Chair's Review: Specific comments to address

2.10 MDA Review 3: 23rd July 2020

Proposals presented at London Review Panel MDA Review

Residential totals (combined):

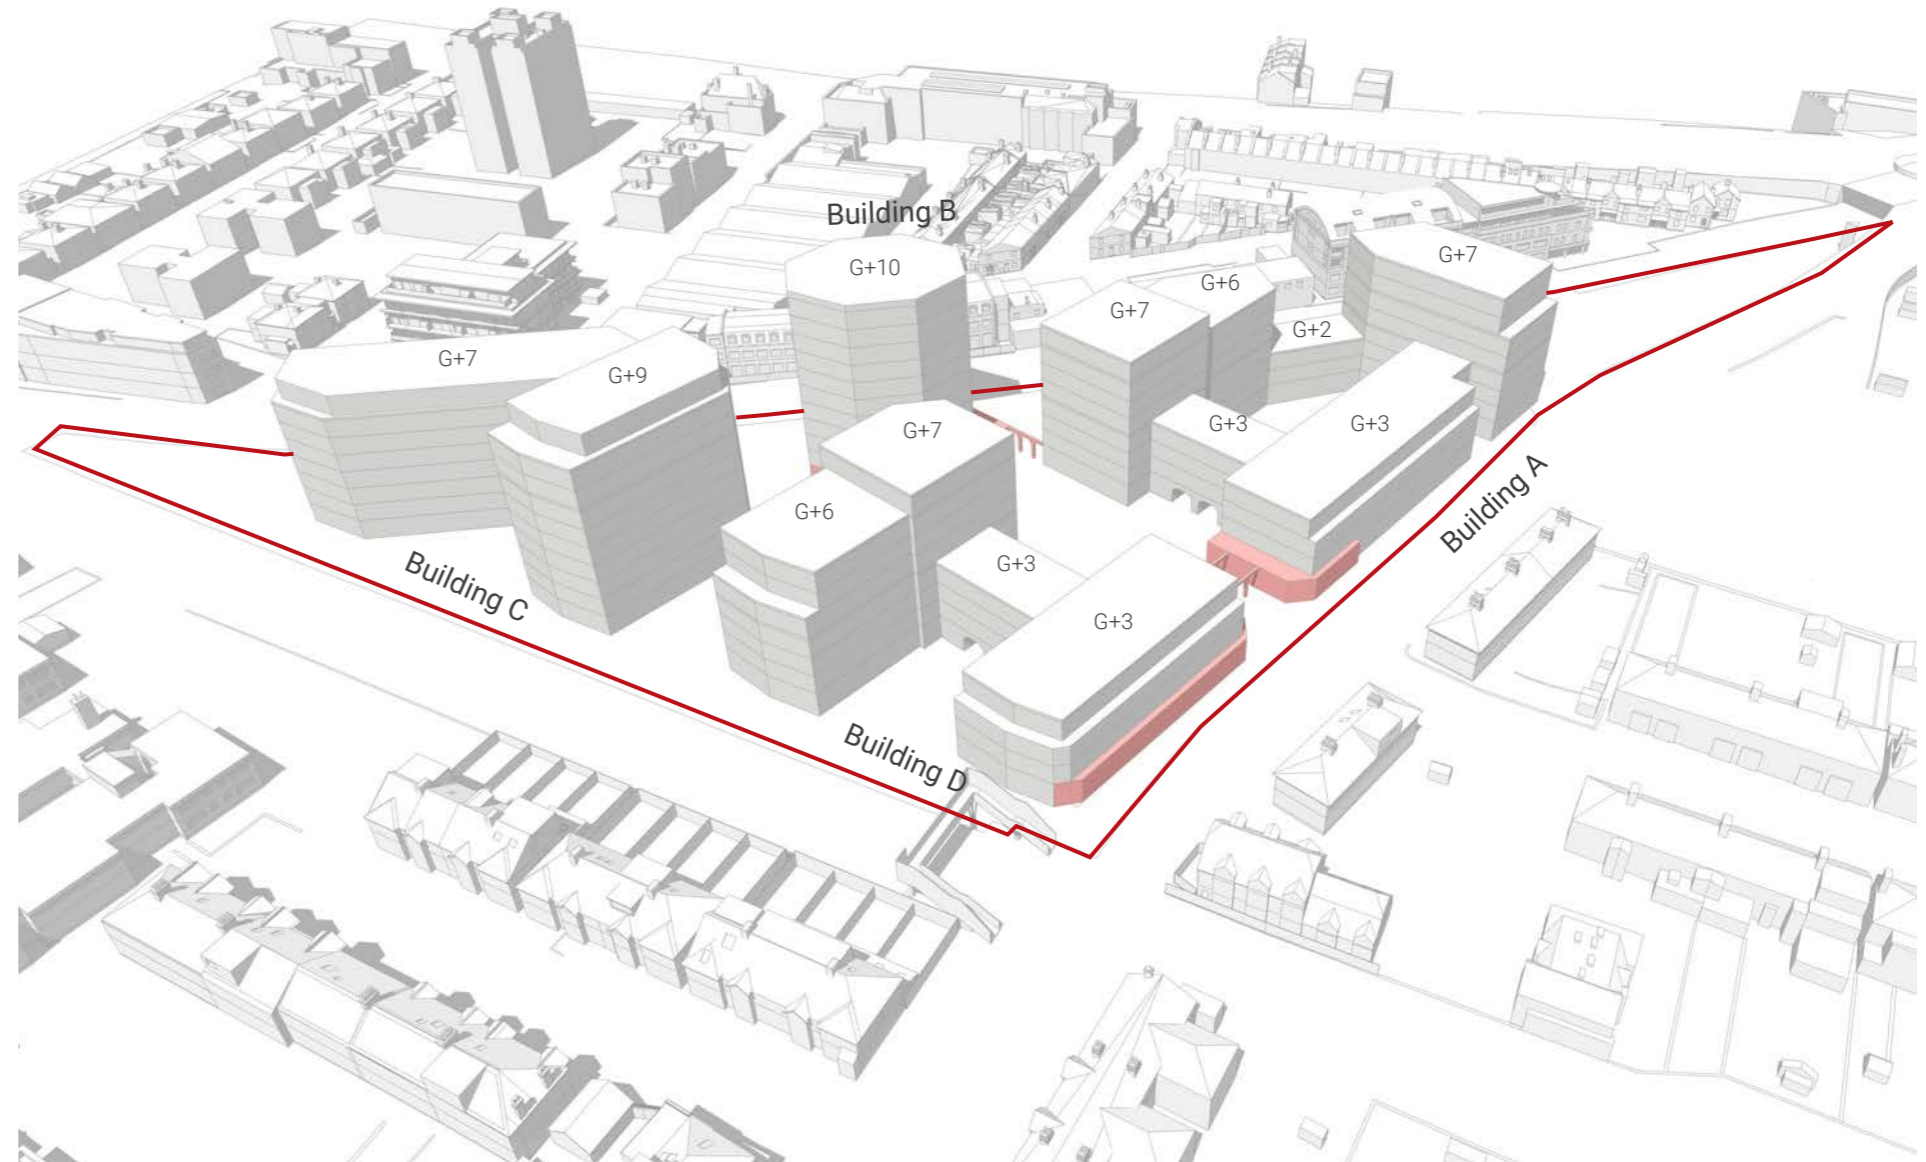
- Thoroughly support the removal of Building E
- Review overlooking of apartments in link buildings
- Consider overheating/shutters/glazing ratio (this can be designed further in stage 3)
- Not convinced by the vines growing over the arches at the entrance to the site
- Ensure landscape aligns with GF dwellings/entrances
- Welcome the increased contrast between the brick and stone texture but ensure the stone colour is warm (does not look like concrete)
- Ensure the metal set-back is high quality/detailed well
- Clarity required over the servicing strategy to commercial units
